ADDENDUM NO.: 1

IFB or RFP NO.: Bid No. 616

Description: Furnish, Deliver and Install

Bleachers Project: NYCCT

A-641.00

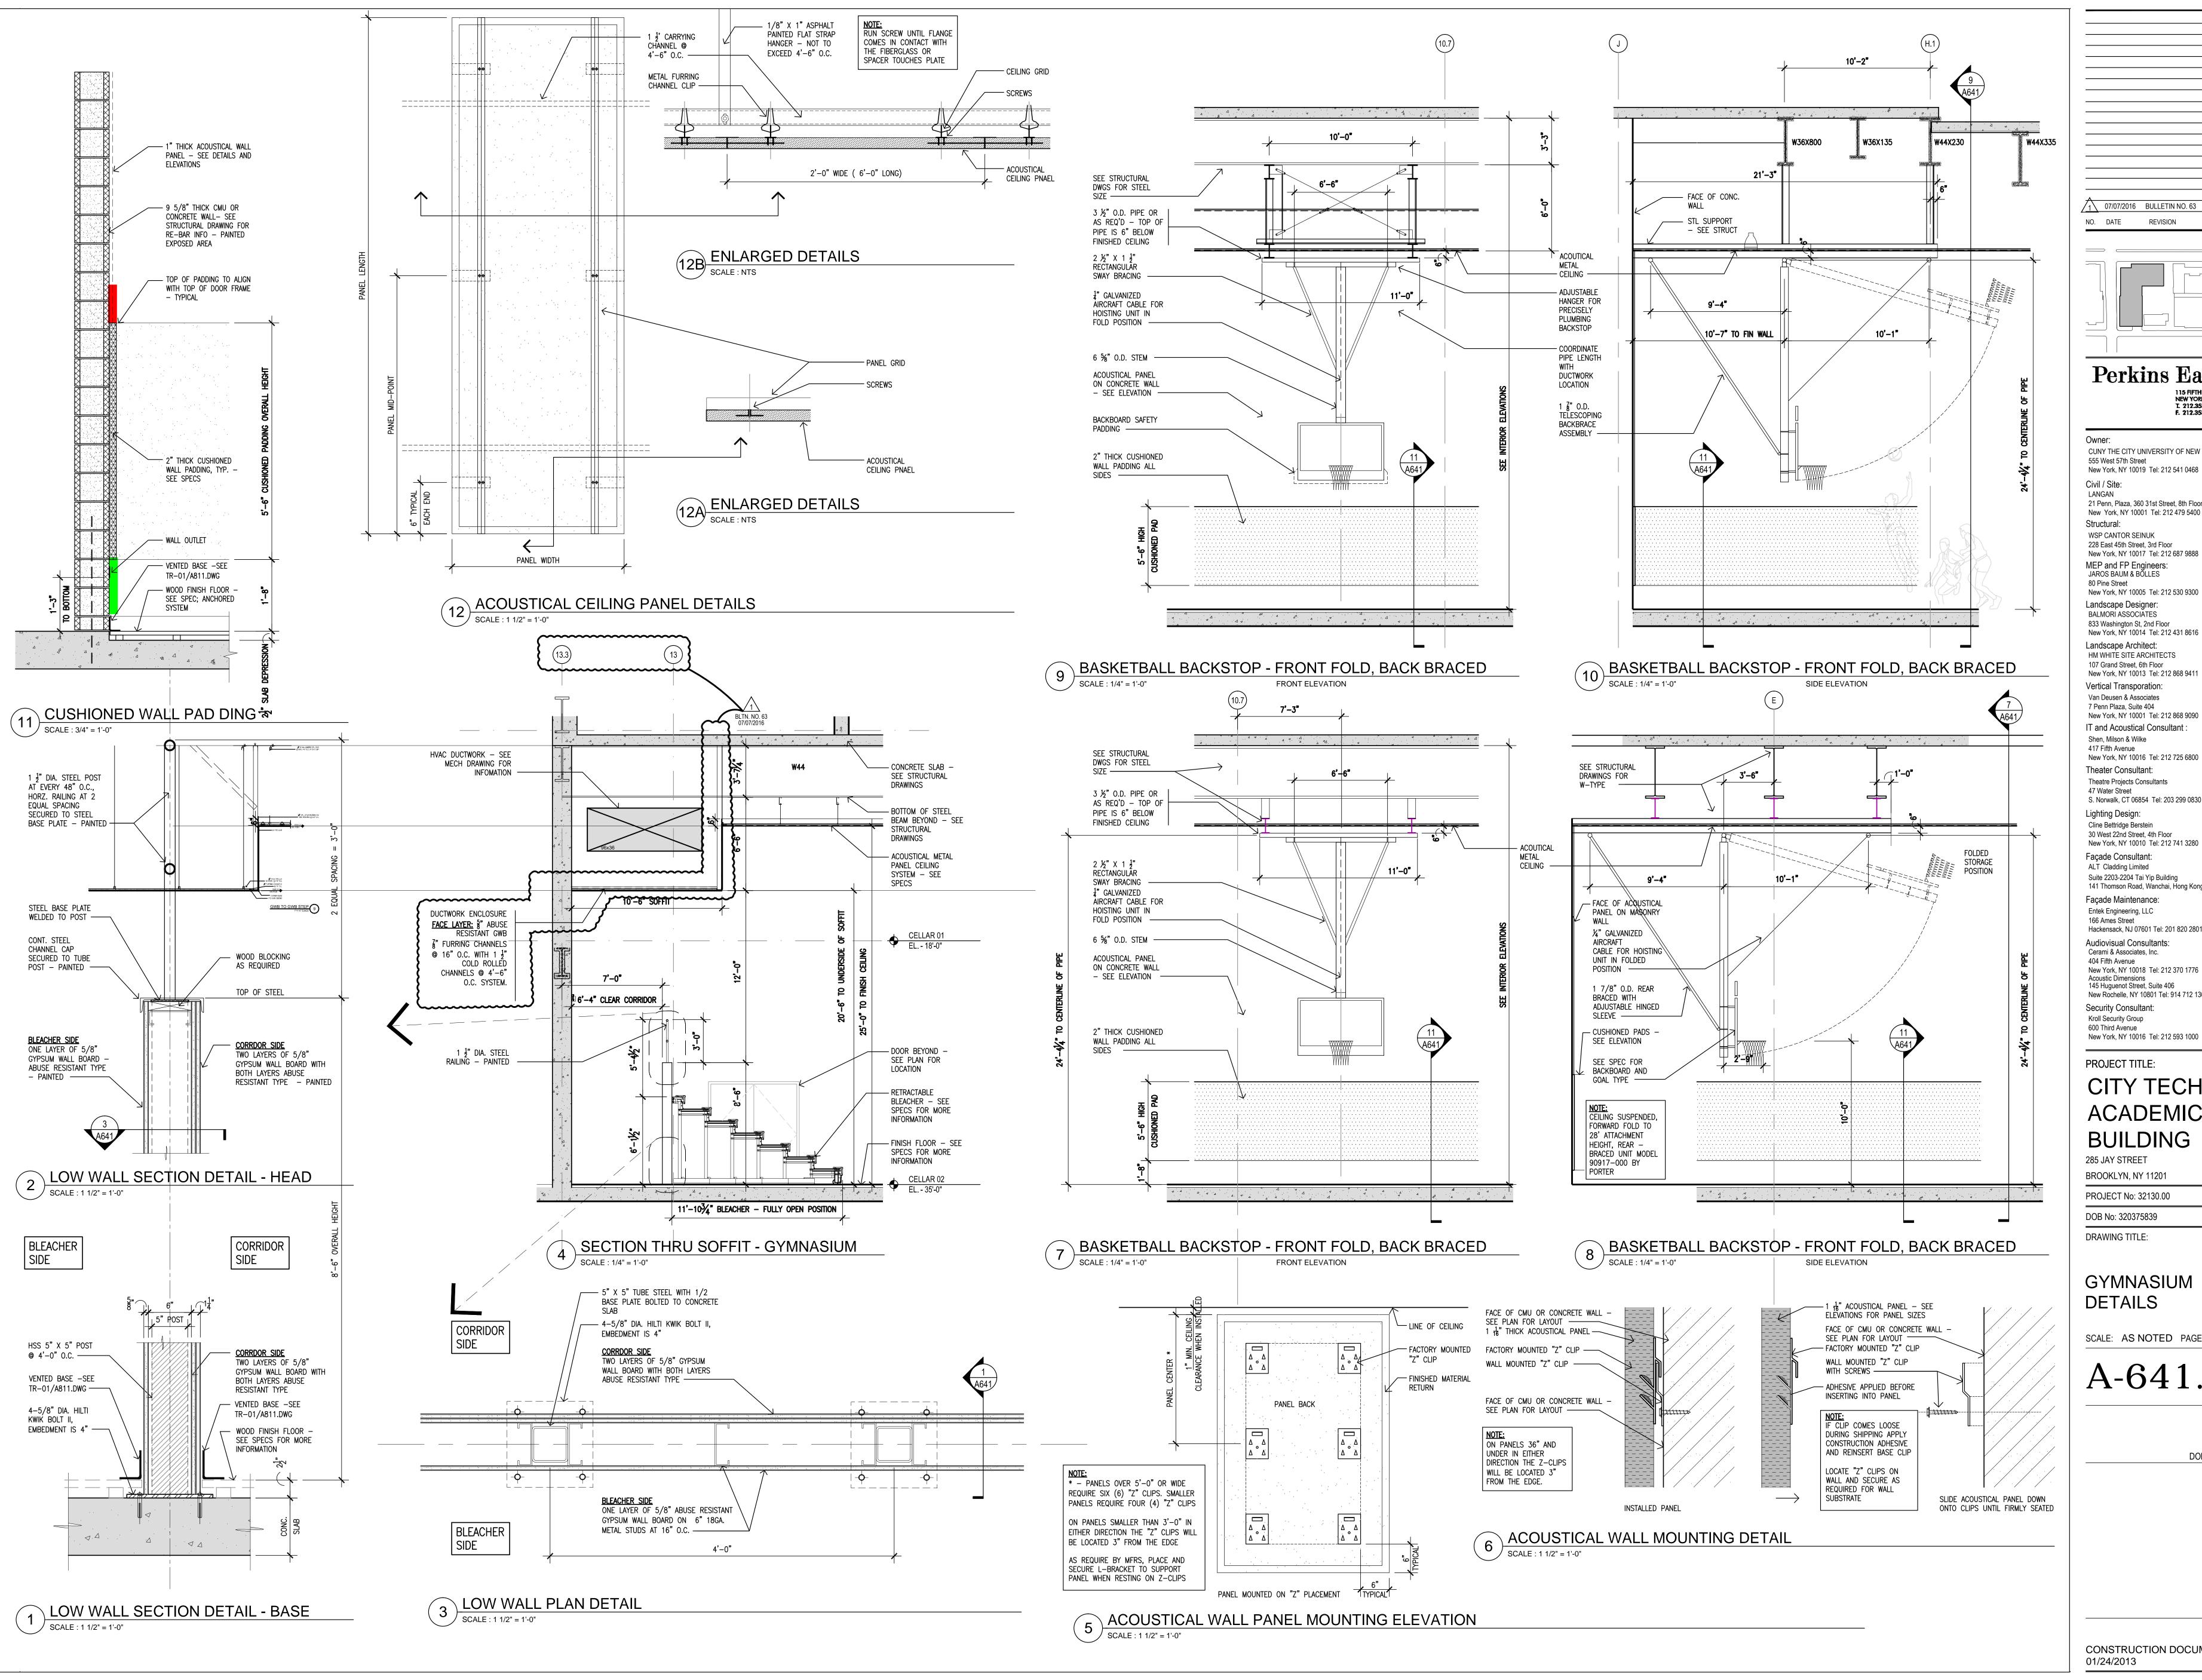
The shop drawings that were provided with the bid documents do not show a wall attachment detail for Bank A. Will Bank A be getting attached to the wall at all or is this bank intended to be a freestanding unit that gets attached to the floor only? Please provide Bleachers as per see A-101, A-641, RFI-711r1 and Specification Section 12 66 00. Copies are attached.

As per the response to RFI 711 there is 1 fixed and 1 telescoping stand. Please confirm on which side the fixed stand and the telescoping stand should be installed as well as the drawings confirming said locations.

A-641 shows a retractable bleacher on the south side of the Gymnasium, please reference drawings indicating fixed stands and their location.

TELESCOPING STAND TO BE NORTH SIDE.

FIXED STANDS ARE ON THE SOUTH.
